Re: - Other Change Application – Lots 9111 and 9112 (Peet), Lot 89  
“other change applications” – Fire Management Plan

**Re: - Other Change Application – Lots 9111 and 9112 (Peet), Lot 89  
"other change applications" – Application no. 2098/2015/MAOC/A  
Response to Assessment Manager Information Request**

Figure 1 – Proposed Layout Plan

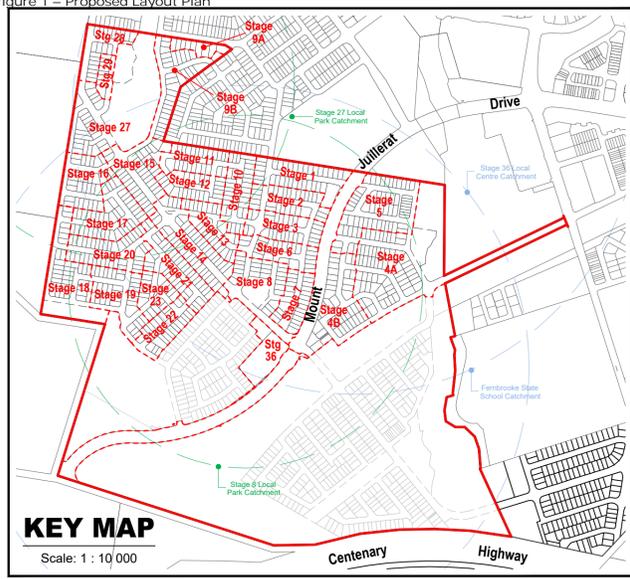
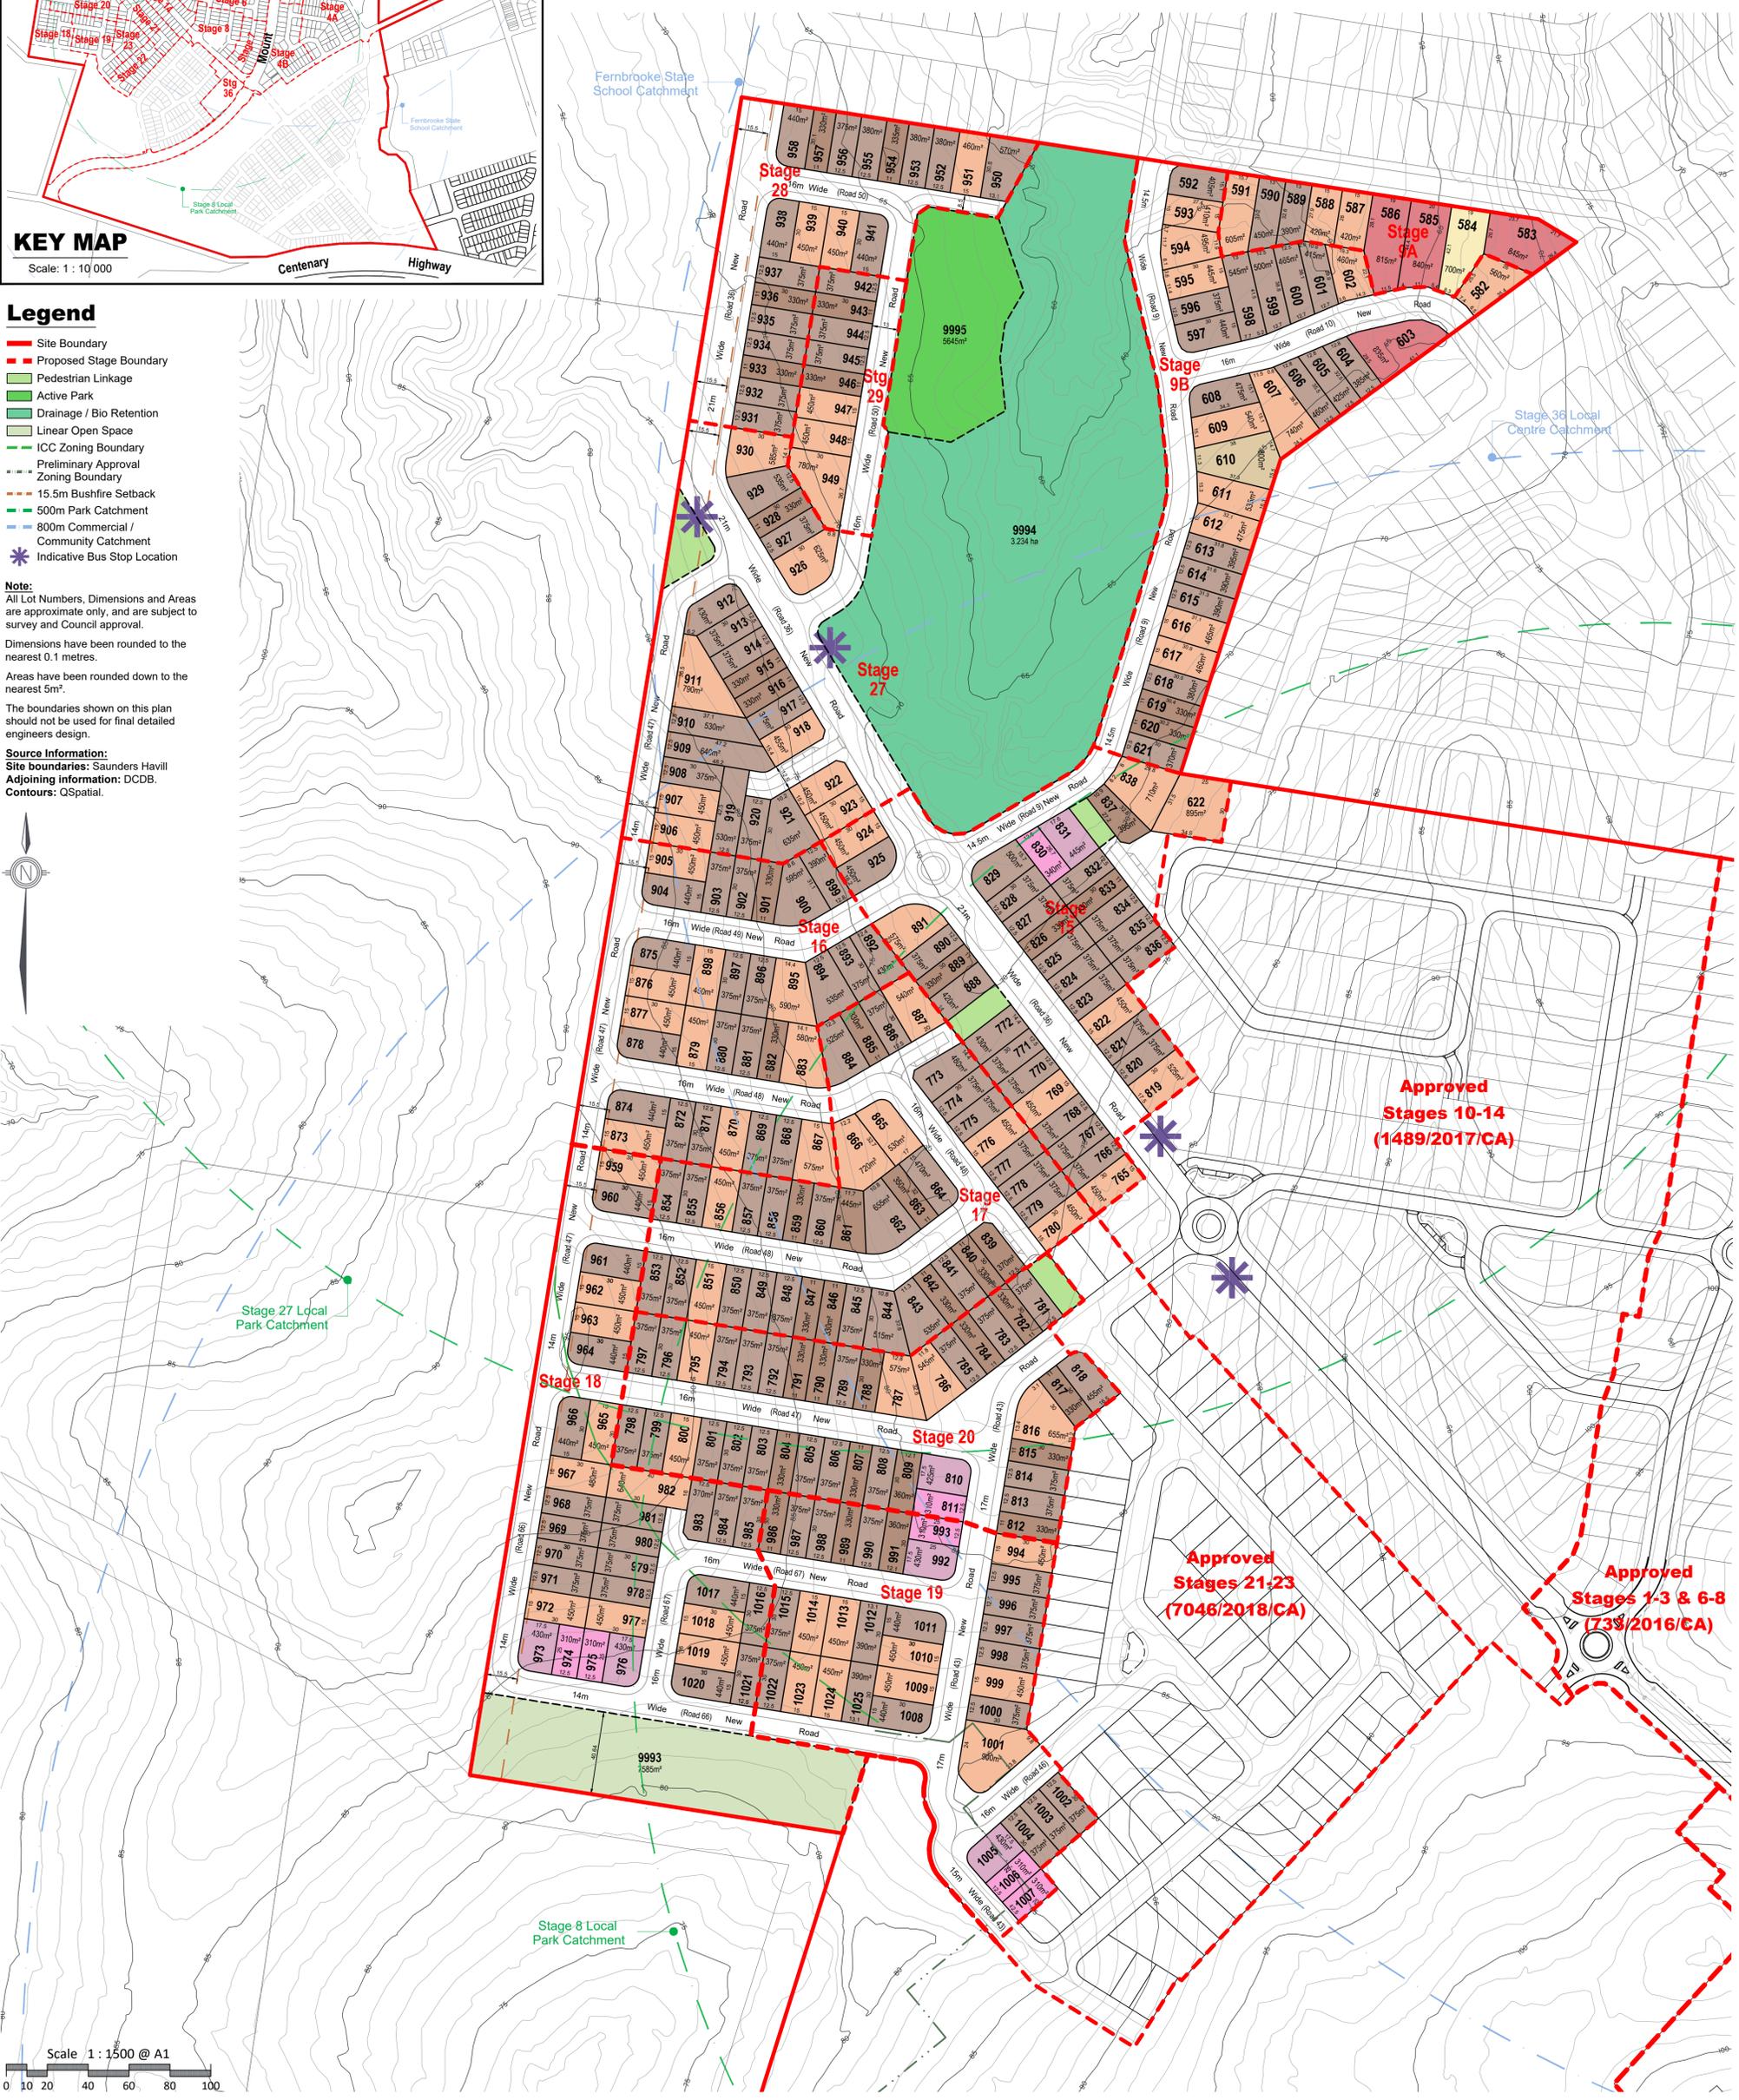
The application seeks to change the current approval with a change in the layout and alignment of internal roadways as well as the shape and size of an area of open space within the northern portion of the layout (see Figure 1, attached).

With respect to bushfire we note apart from a realignment to the internal roadway and therefore lot alignment, there is very little change with respect to setbacks and road widths that abut the area of potential hazardous vegetation to the west.

The approved plan entailed a 14 metre wide roadway along the western boundary of the development and the Other change application layout also has a 14 metre wide roadway.

Based on the above and the use of a Radiant heat flux of 29kW/m<sup>2</sup> as the extent of an acceptable level of risk, any structure located between 10.4 metres and 15.4 metres would be at an acceptable level of risk.

With regard to the setback provided by the roadway i.e. 14 metres and a potential front of lot setback of at least 1.5 metres resulting in a total setback of 15.5 metres, this would be sufficient for a structure to be well within an acceptable level of risk.

| <p>a) The Fire Management Plan RF18-0473, prepared by Rob Friend &amp; Associates and dated 10 January 2019 indicates that a minimum 15.5m buffer from the western property boundary is required. The applicant is requested to amend the proposed plans to clearly identify the extent of the buffer, including impacts on proposed lots 873-875 and 904-912.</p> <p>b) The applicant is requested to provide information as to why the minimum building setback from the western property boundary has been reduced in the amended report.</p> |

With respect to Item 7, a) the 15.5 metre setback will be provided in an updated layout plan.
